Request For Information RFI-097

Subject: BP3 Art and Brand Wall Supplemental Steel
Project: Steamboat - BV BP Promenade and Goldwalk
Address: 2305 Mount Werner Circle
Steamboat Springs CO 80487 USA
Phone:
To: Bryan Sculthorpe
Saunders Construction, LLC
From: Saunders Construction, LLC

Subject: BP3 Art and Brand Wall Supplemental Steel
Project: Steamboat - BV BP Promenade and Goldwalk
Address: 2305 Mount Werner Circle
Steamboat Springs CO 80487 USA
Phone:
To: Stephen Carrola
Design Workshop Inc
From: Saunders Construction, LLC

1B-L6-01

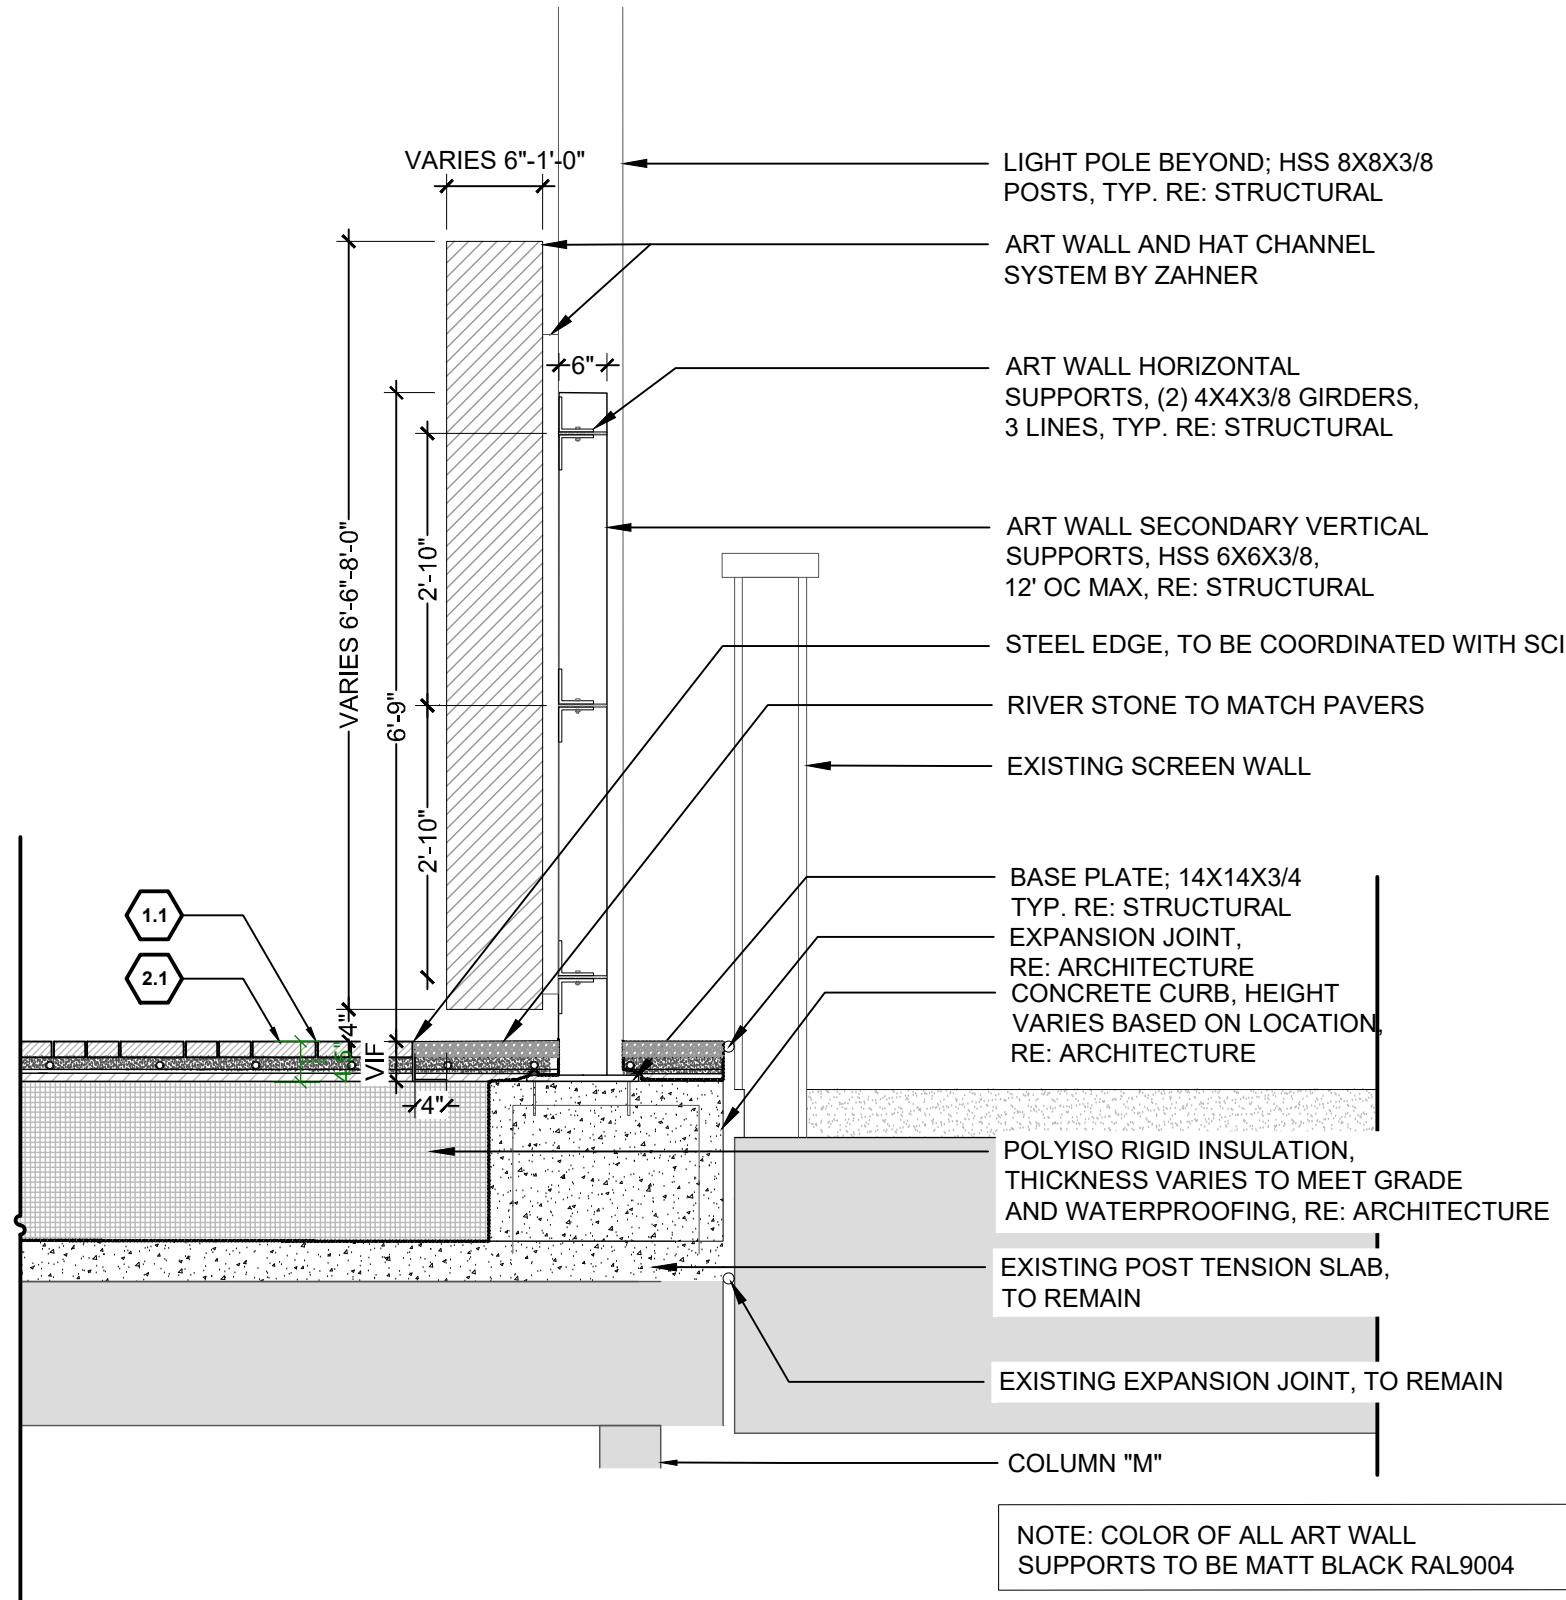
Please confirm bootleg supplemental steel package should be included in scope. If so- please provide updated construction documents that are reflective of additional supplemental steel required.

DW HAS UPDATED OUR BP3 GOLDWALK DRAWINGS TO REFLECT THE REQUIRED SUPPLEMENTAL STEEL TO SUPPORT THE ART AND BRAND WALLS. ADDITIONALLY, WE HAVE UPDATED THE LIGHTING SCHEDULE AND LIGHTING PLAN TO INCLUDE THE F6 FIXTURES. REVISED DRAWINGS INCLUDE: L0-04 GENERAL INFORMATION, L3-01 MATERIALS PLAN, L4-01, L6-01 LIGHTING PLAN, L7-02 ART WALL DETAILS, L7-03 BRAND WALL DETAILS. SCARROLLA, DW, 10/01/21

IN ADDITION TO THE STEEL QUESTION ABOVE, CIRCUITING AND CONTROL INFORMATION HAS BEEN PROVIDED IN THE ATTACHED DRAWING UPDATE FOR ADDED LIGHTING WITHIN THE ART WALL AND BRAND WALL. REFER TO ADDITIONAL CORRESPONDENCE (PAGES 7-21 HEREIN) FOR FIELD COORDINATION AND INSTALLATION CLARIFICATIONS.

1B-L7-02

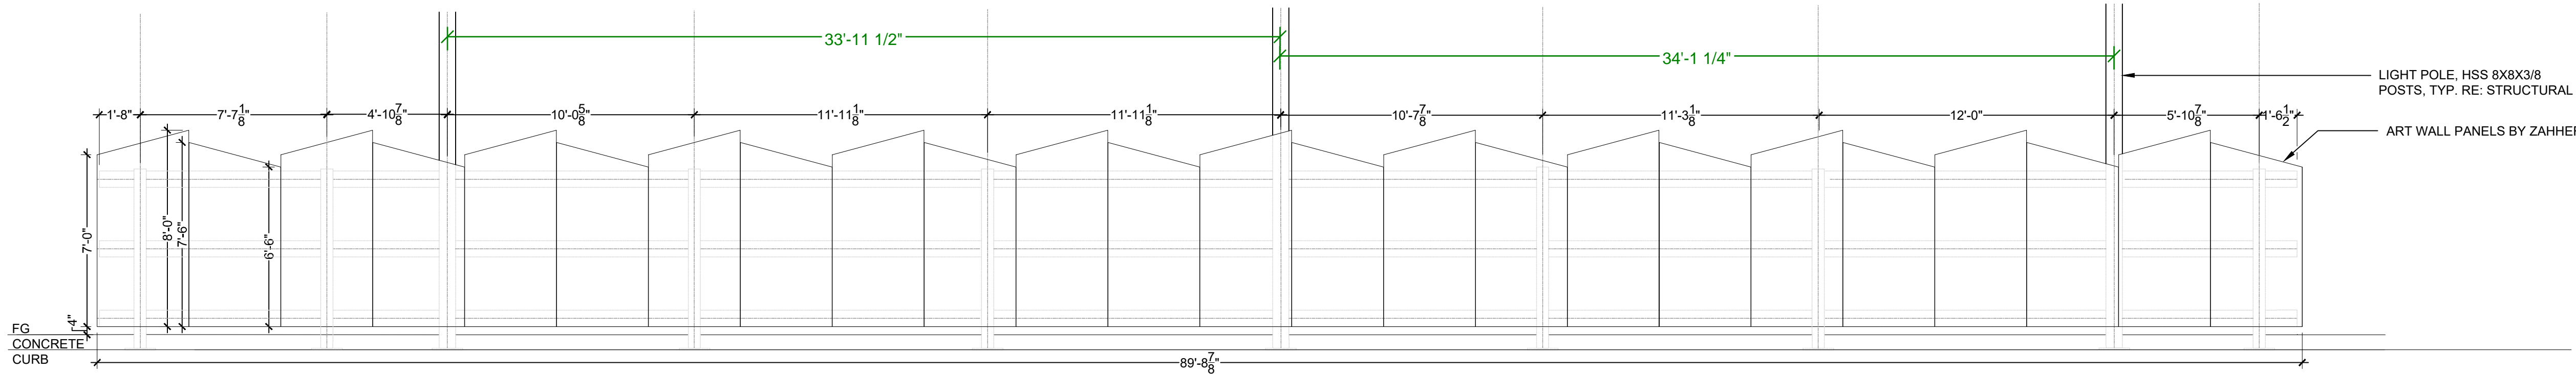
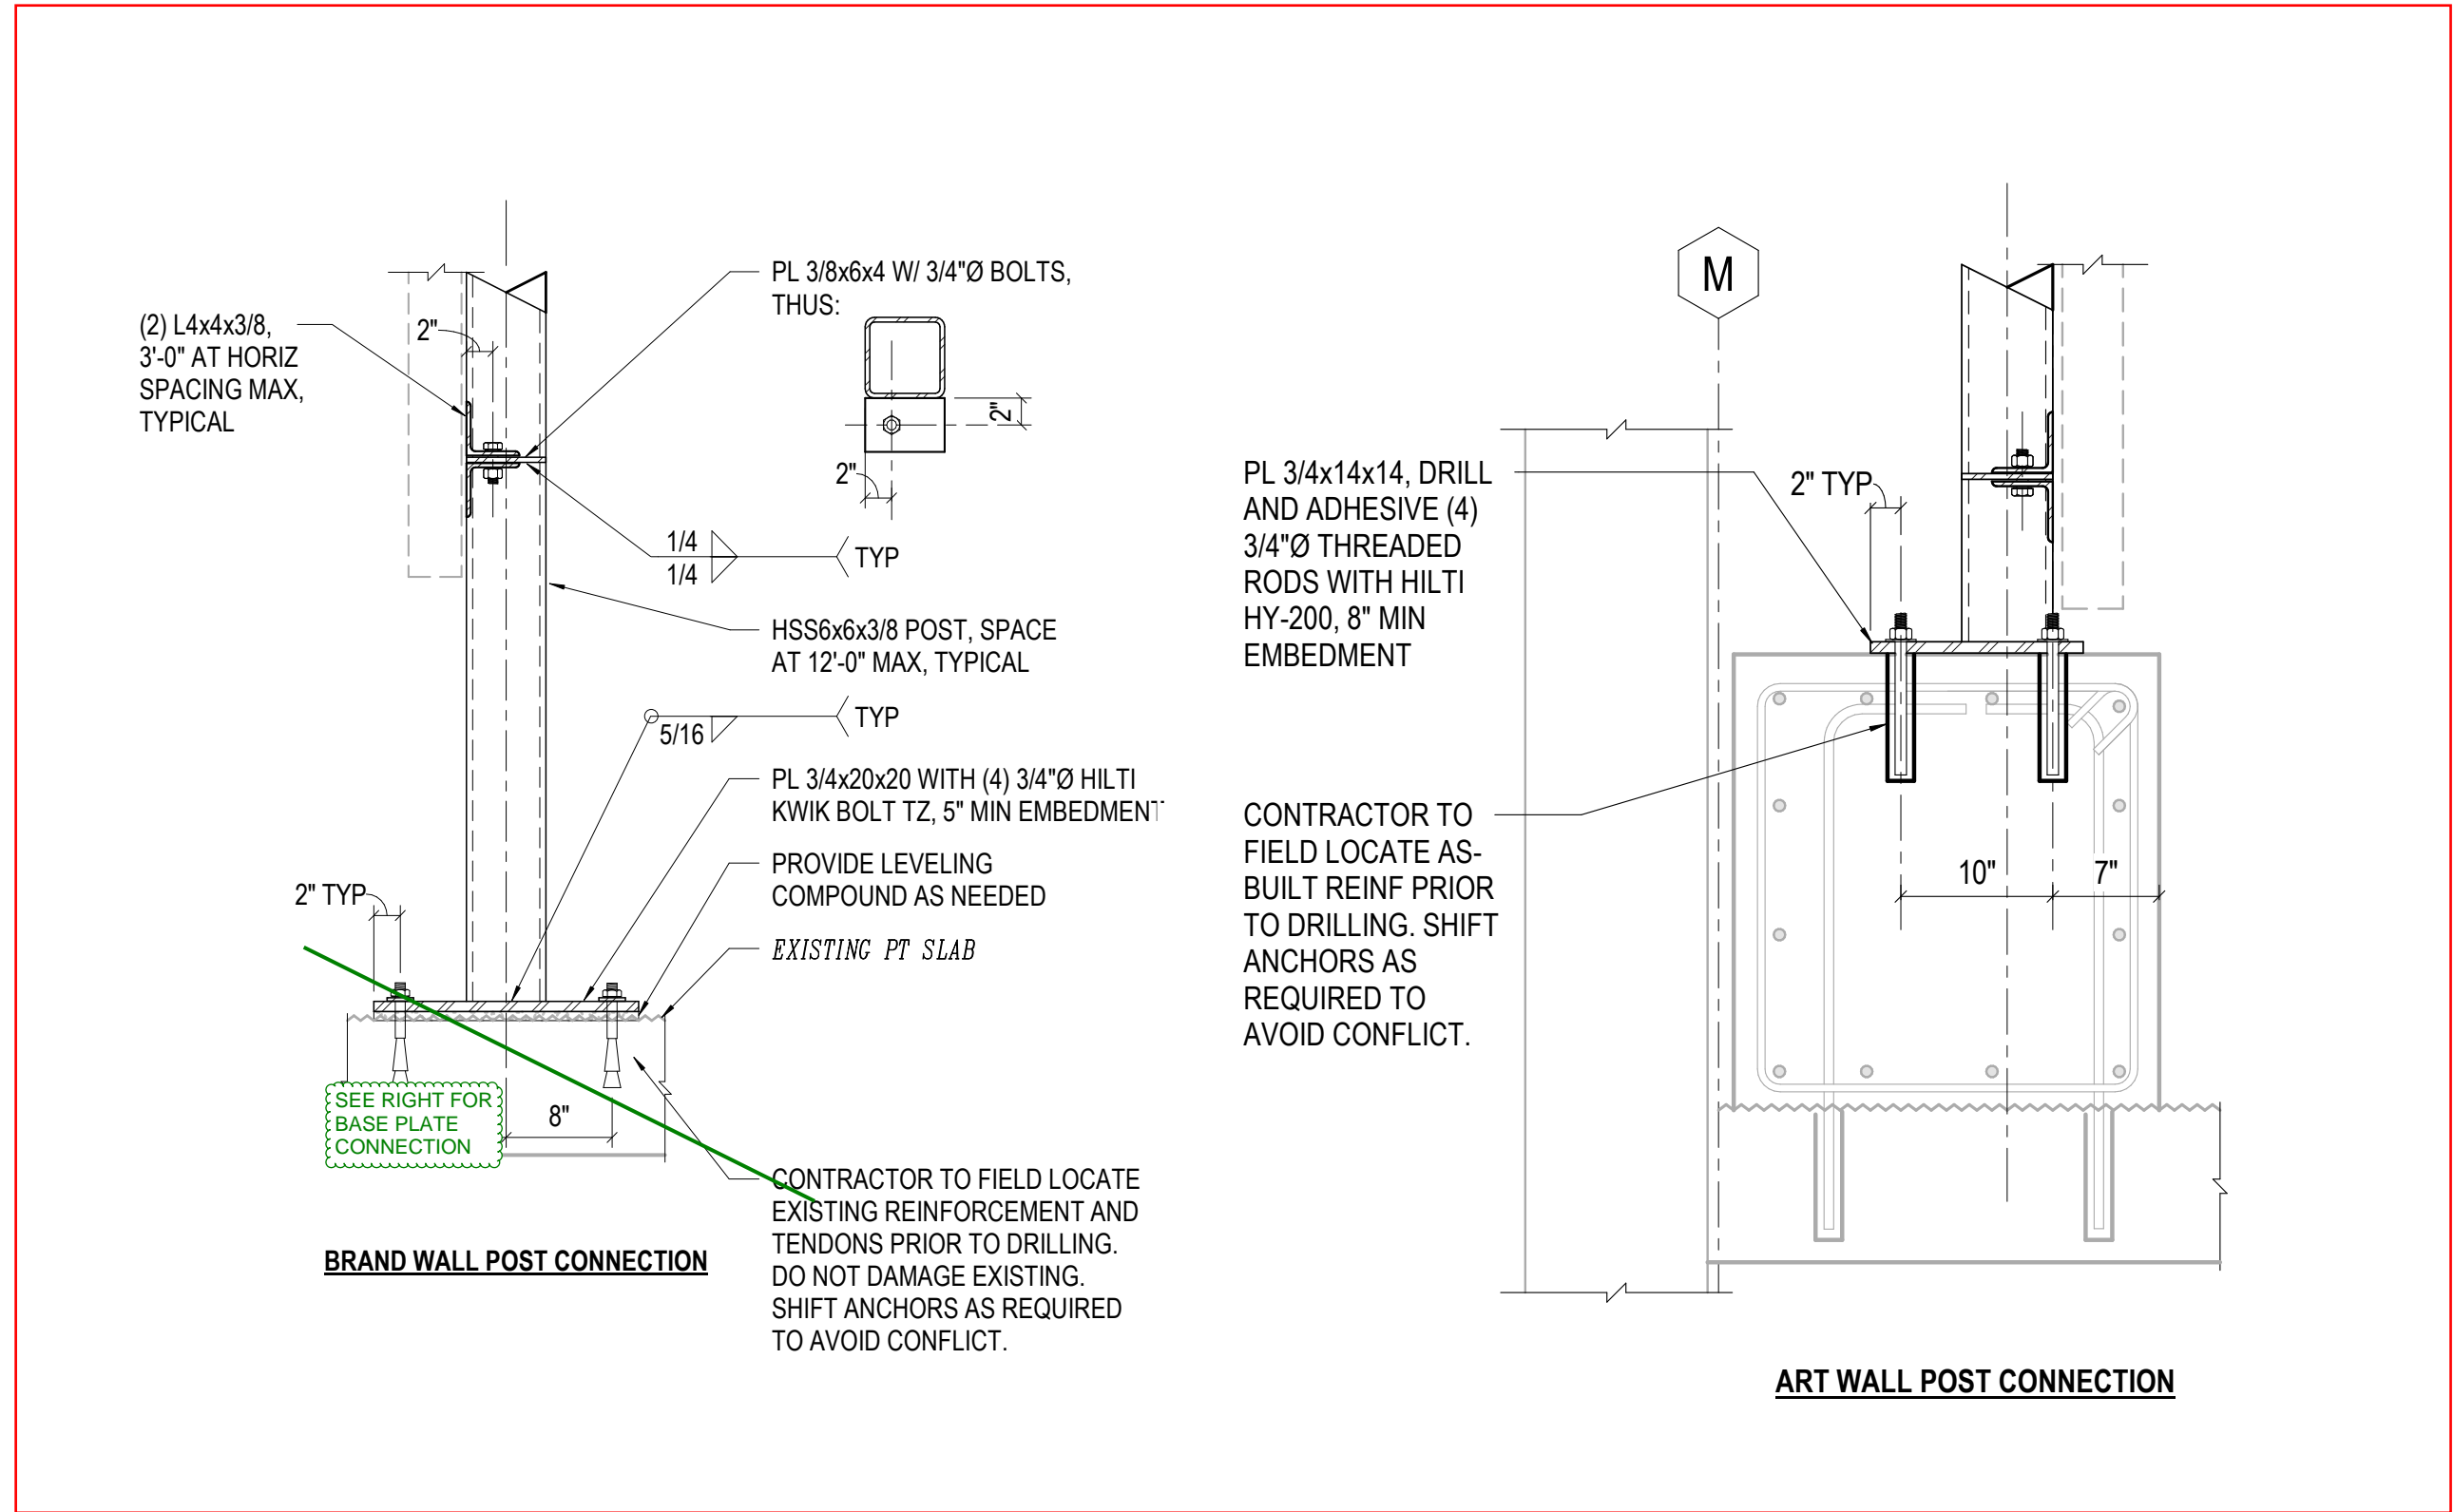
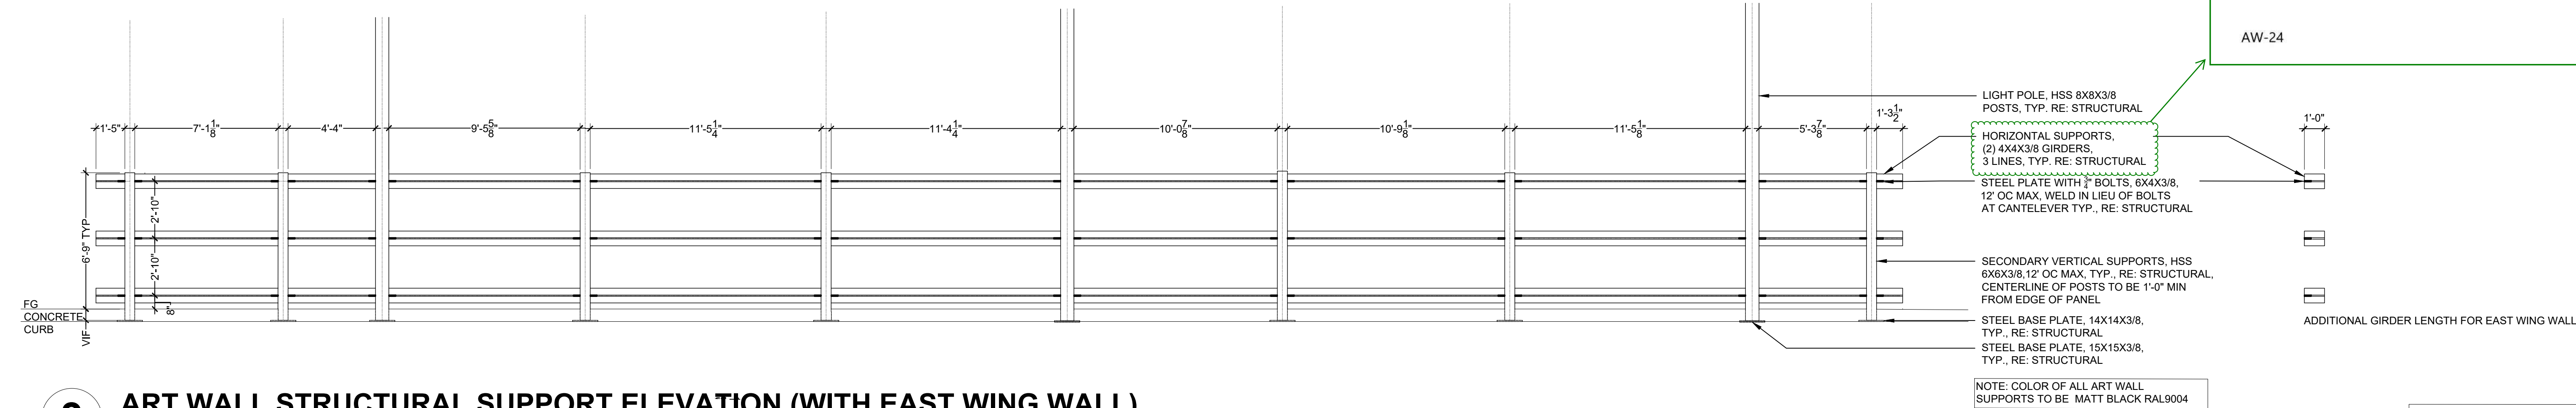
Ref attached correspondence and bootleg drawings sheets, the supplemental steel for the Goldwalk and Artwall is required to be included in BP3 Goldwalk scope.
